TERRY & HOWELL

RECOMMENDATION MEETING

AUGUST 18, 2015 | DPD #3017451 | 14-018

PLAN STUDY 1

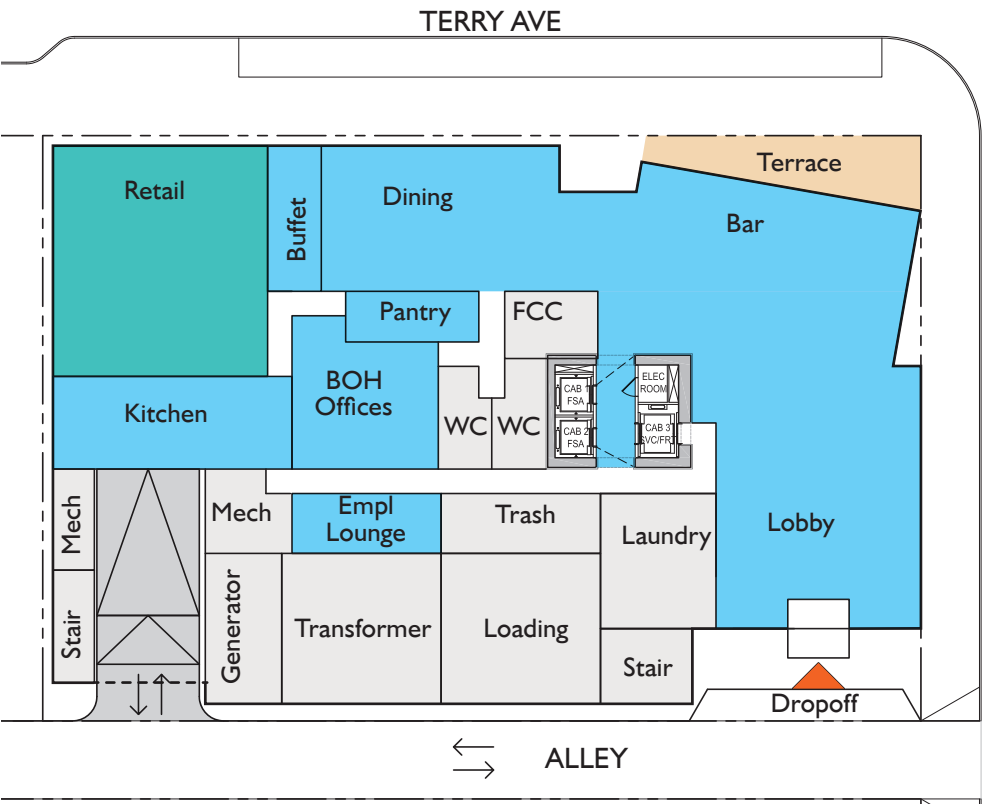
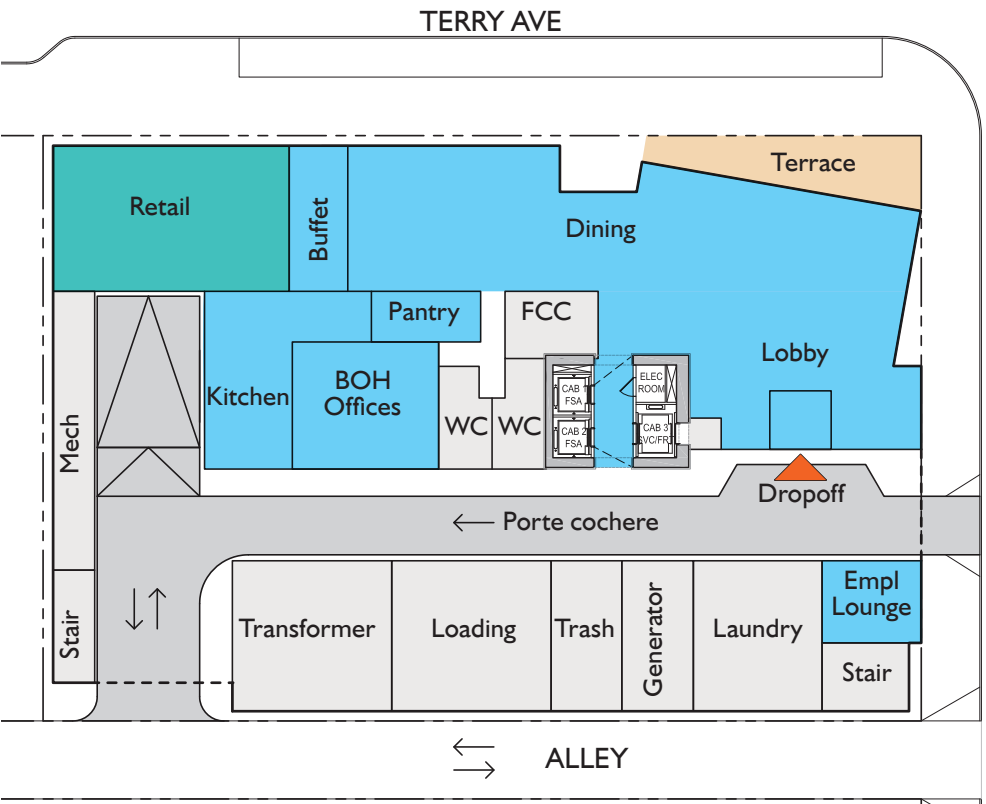
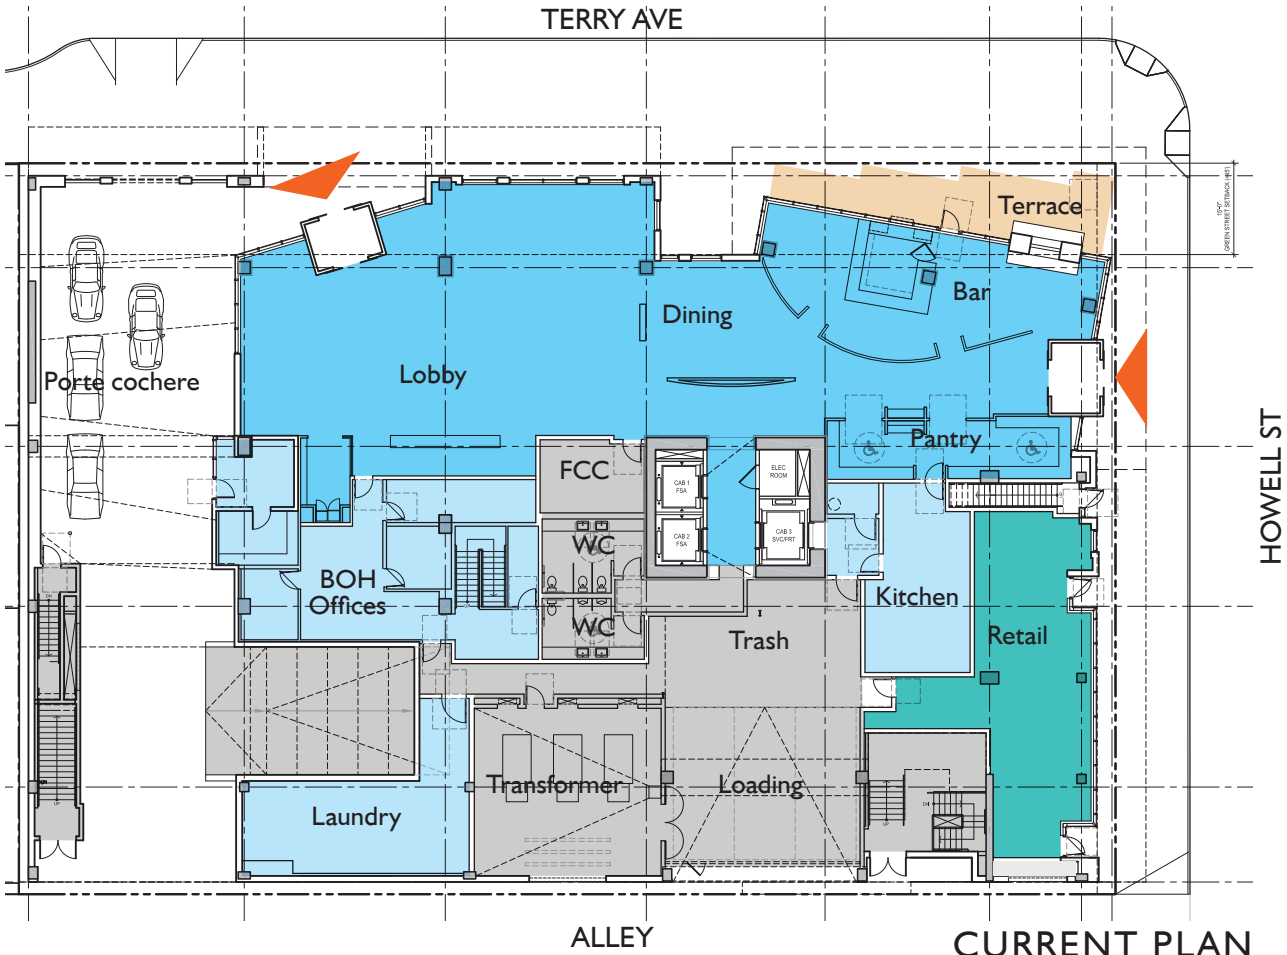
The alley should be more thoroughly explored as an entry approach for drop-off for the hotel. The porte-cochere could sit parallel to the alley. Enhancements to the alley, with pavers, festival and other types of lighting and an attractive facade, could produce a strong and convincing sense of place in the spirit of Hotel 1000 at First Ave and Madison and The Olivian (apartment building) at Eighth Ave and Olive Way

OPTION 1

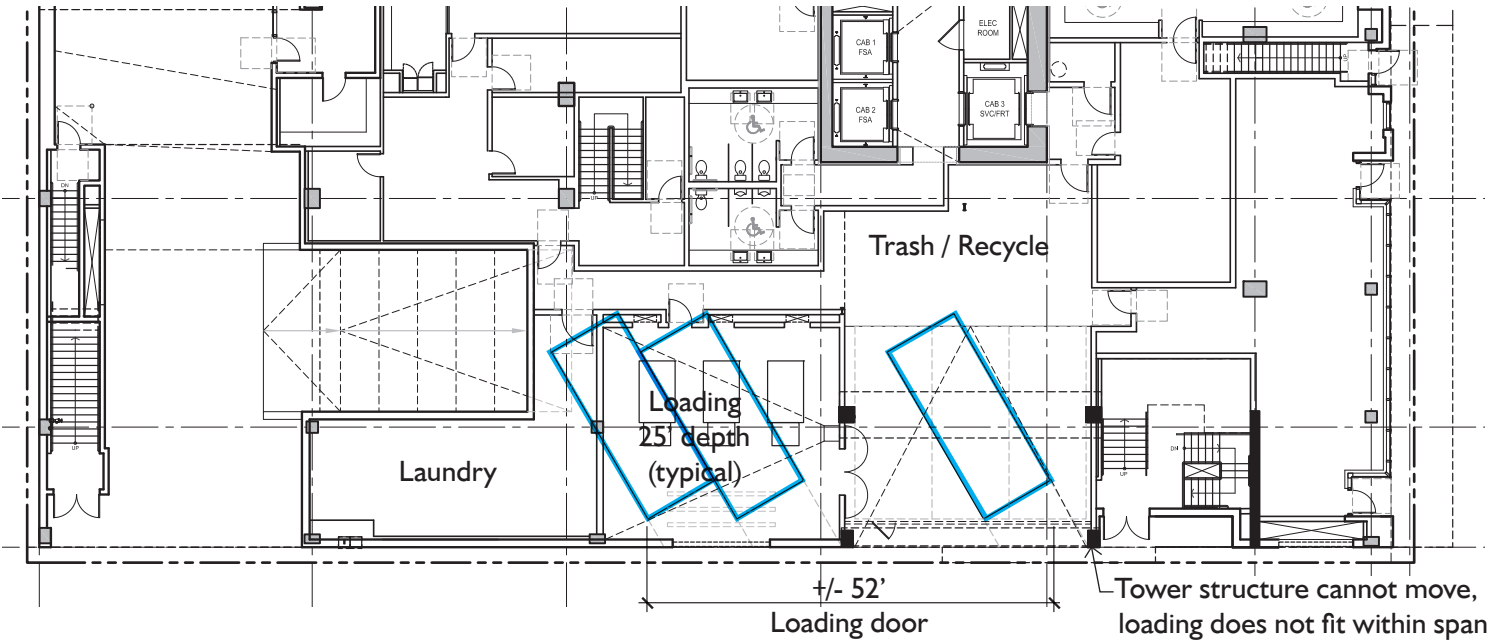
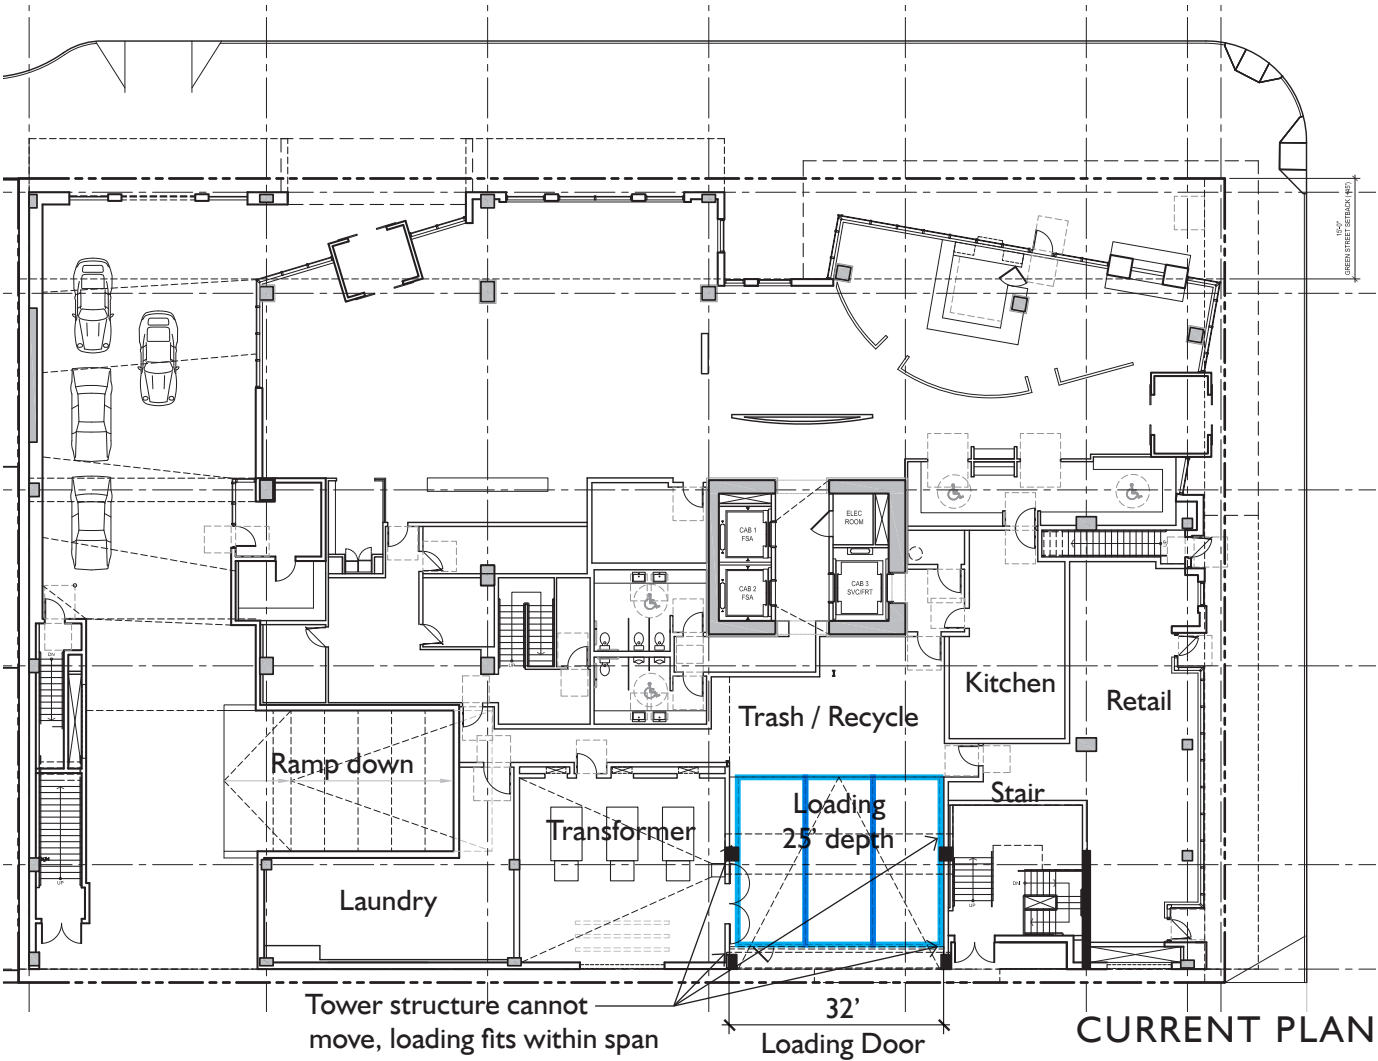
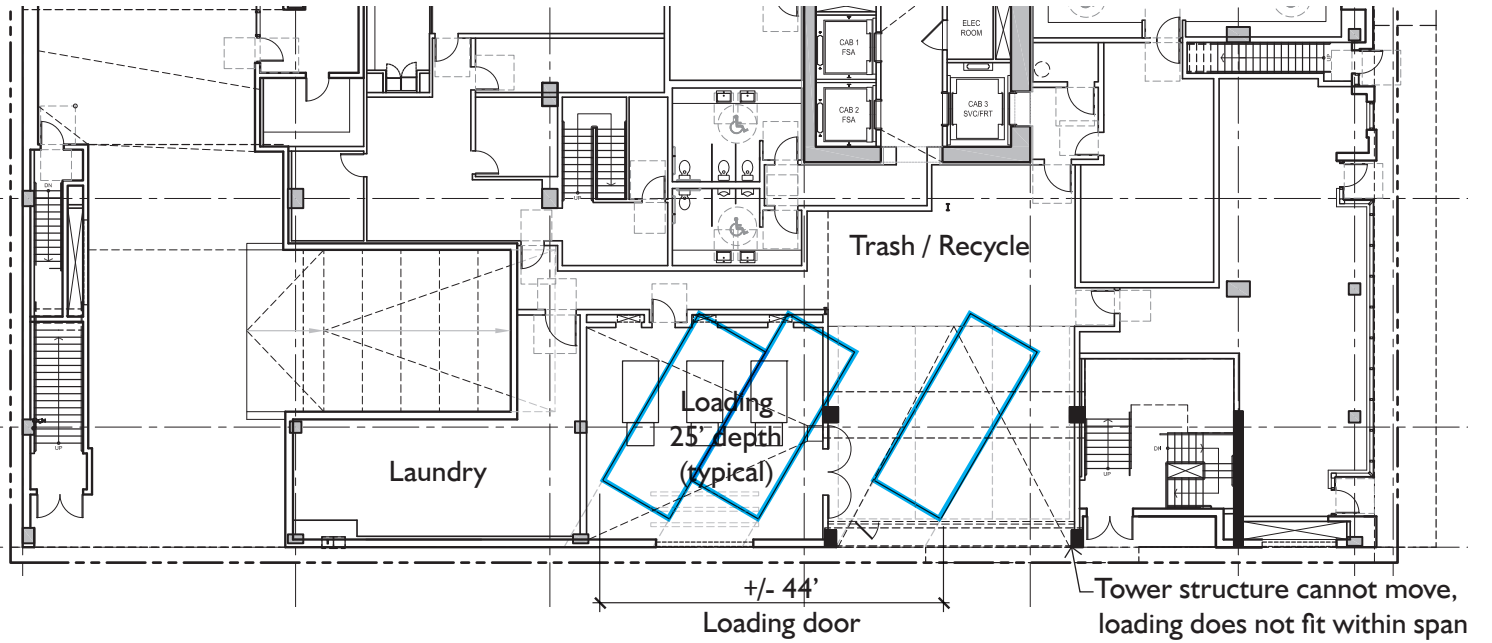
Consider angling the loading berths as suggested by a member of the public
